Comment Letter 31

Re: Draft Environmental Impact Report for The McKinley Village Project (P08-086)

3 - Responses to Comments

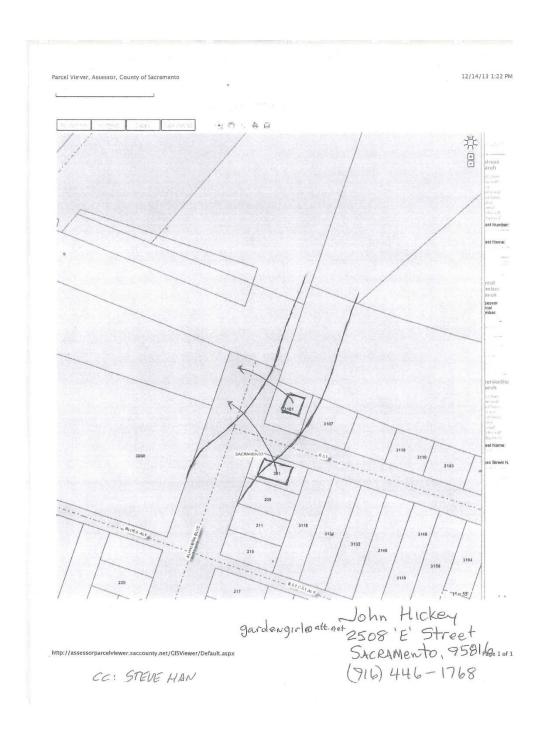
A TUNNEL @ ALHAMBRA WAS PROHIBITIVELY EXPENSE SINCE ALLIAMBRA

BIND. WAS TOO CLOSE TO BUSINESS 80 FOR THE PROPER SHOPEING

É SAFTEY MEASURES TO BE PUT IN PLACE.

I FEEL THAT A RESONABLE REALIGNMENT Of ALLAMBRA
BLVD e'B' Street Could/would reduce the prohibitive EXPER,
to A REASONAble EXPENSE" AND Allow A TUNNEL to
be bored At Alhambra.
